# UNITED STATES PATENT AND TRADEMARK OFFICE

10/531,786

<b>Office Action Summary</b>	<b>Application No.</b> 10/531,786	<b>Applicant(s)</b> WEINSTEIN ET AL.	
	<b>Examiner</b> Krishnan S. Menon	<b>Art Unit</b> 1797

## DETAILED ACTION

Applicant's figure 10, assumed to be best representing the claims in comparison with figure 5 of Latour and figure 6 of Friedman.

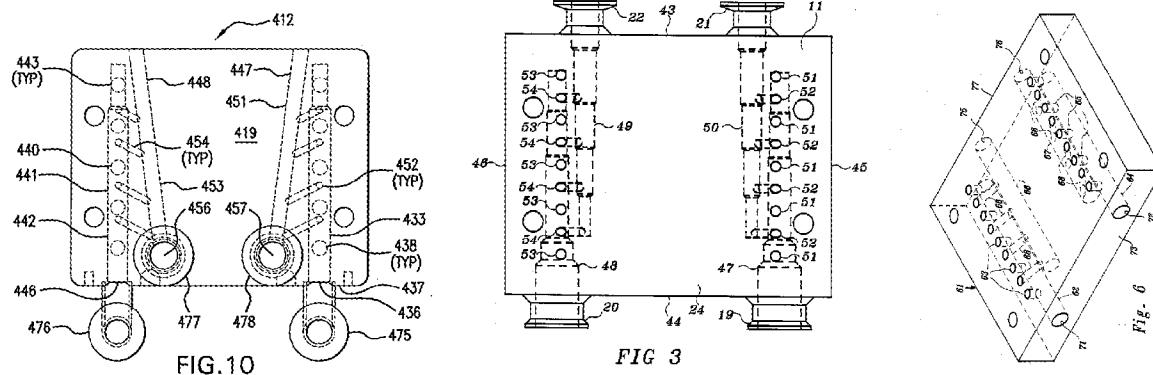
Claims 11-19 are rejected under 35 U.S.C. 103(a) as being unpatentable over Latour et al (US 4,849,102) and/or Friedman (US 4,715,955).

Friedman teaches a filtration housing with an end plate having parallel feed and retentate channels, and filtrate channels, wherein the filtrate channels have transverse portions, the transverse portions forming acute angles with the upper surface of the end plate. See fig 6 above, as well as fig 4 of the reference. Particularly, this reference teaches:

Latour teaches a filtration housing and cassette assembly (12, see figures), in which the housing comprises first and second parallel plates (11,13,14), plate 11 having feed inlet (19) and retentate outlet (20) channels at opposite edges, and filtrate channels (21,22) having first portions (49,50) and second transverse portions (connecting 49 to 54 and 50 to 52) as claimed. These channels communicate with the respective feed, retentate and filtrate channels of the cassettes. The plates are movable on frames to change the number of cassettes loaded as desired.

The teaching of the reference differs from the claims in the ‘acute’ orientation of the transverse filtrate channels with respect to an upper surface of the first end plate. Friedman teaches the transverse filtrate channels as being at an acute angle with a face of the end plate, but this does not appear to be the “upper surface” as claimed. The [first] plate (11) of Latour is also a central plate (communication to the filter cassettes from both major surfaces), whereas the applicant depicts it as an end plate (communication to the cassettes only from one major surface). Latour refers to Friedman and teaches his design as an improvement over that of Friedman, who has the plate with inlet and outlet channels at and end. However, the “acute” orientation of the transverse filtrate channel is only an obvious design change in shape and/or orientation, which one of ordinary skill in the art is capable of; and are not patentable unless can be shown otherwise. Changes of size, shape, etc without special functional significance are not patentable. *Research Corp. v. Nasco Industries, Inc.*, 501 F2d 358; 182 USPQ 449 (CA 7), cert. denied 184 USPQ 193; 43 USLW 3359 (1974). Applicant

has not demonstrated any criticality of having the acute angles in the transverse filtrate channels to overcome a prima facie case of obviousness.
